Client: City of Petaluma Department of Public Works
Project Location: Lucchesi Park, 320 N McDowell Blvd, Petaluma, CA
Inspection Date: July 17, 2024
Arborist: Ben Anderson

URBAN FORESTRY ASSOCIATES, INC.

Josh Minshall, senior civil engineer with the City of Petaluma, asked me to meet him in Lucchesi Park, where the city plans to install a new skatepark. Prior to our meeting, he provided me with the 50% plans for review. My task was to assess the impact of the construction on the existing trees and document their condition.

Figure 1. Map showing tree and fencing locations.

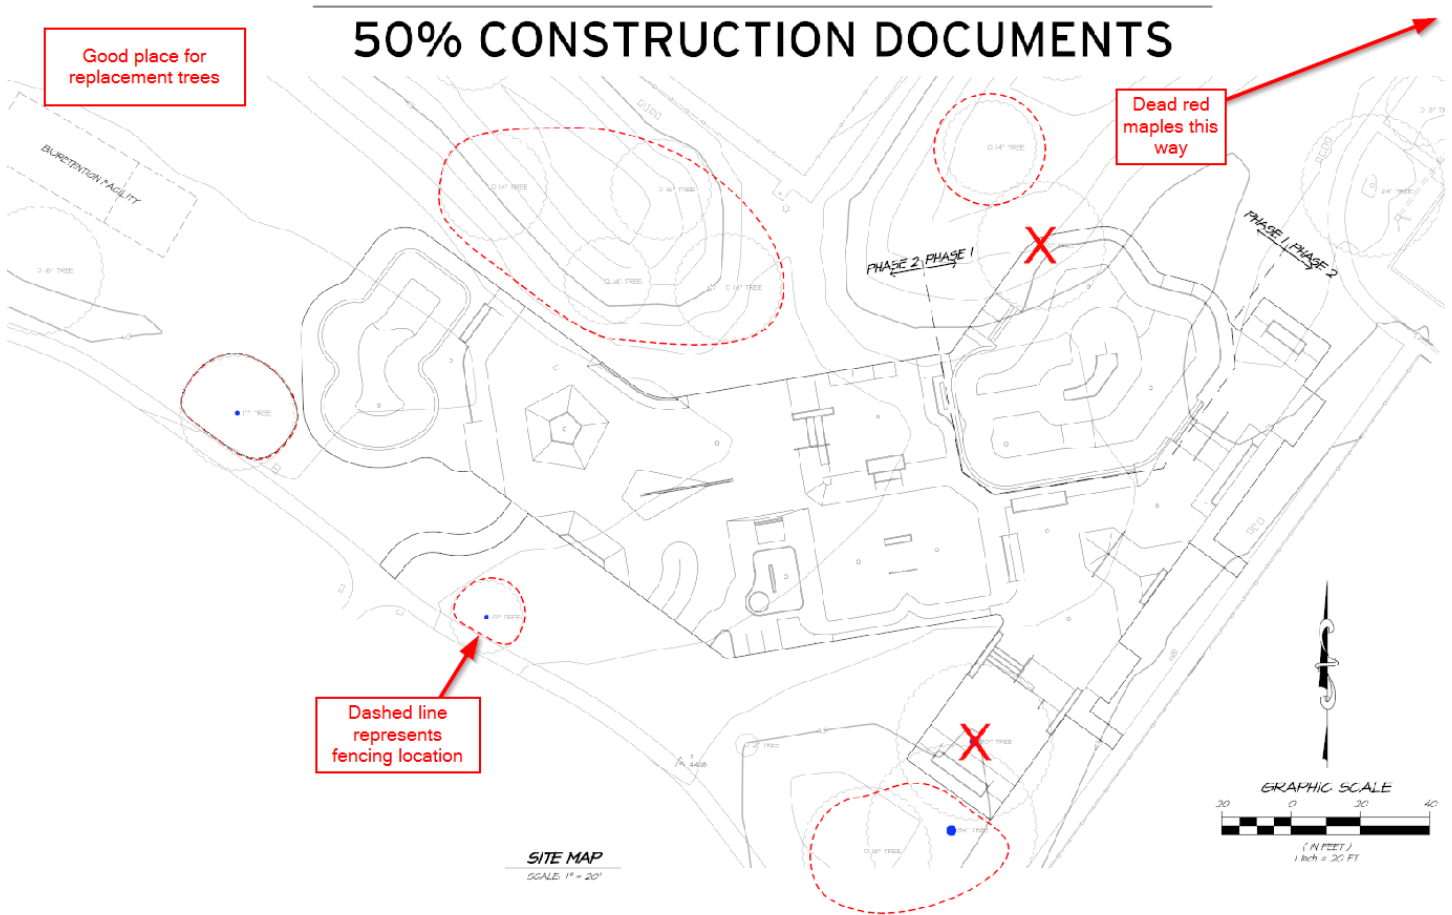
Along with the young cedar, the Modesto ash and London plane tree within the skate park footprint will be removed. Due to the two larger trees, the cedar removal will not be noticeable. For the Modesto ash on the south corner, all excavation should ideally stay at least 10 feet from the tree's base. While retaining the tree even without this modification is possible, the outcome will depend on the roots encountered during excavation. Keeping excavation outside this radius greatly increases the likelihood of retaining the tree in a healthy and stable condition.

For the other trees close to the construction area, heavy equipment is likely to drive over their roots. These trees should have tree protection fencing installed 15 feet away from their trunks. This fencing should be a minimum of 4-foot-high metal deer fencing labeled with tree protection signage. Ensuring this protection will help maintain the trees' health and stability.

- Protect roots: Install tree protection fencing at least 15 feet away from the trunks of trees near the construction area (closer to the skatepark side of the ash above).
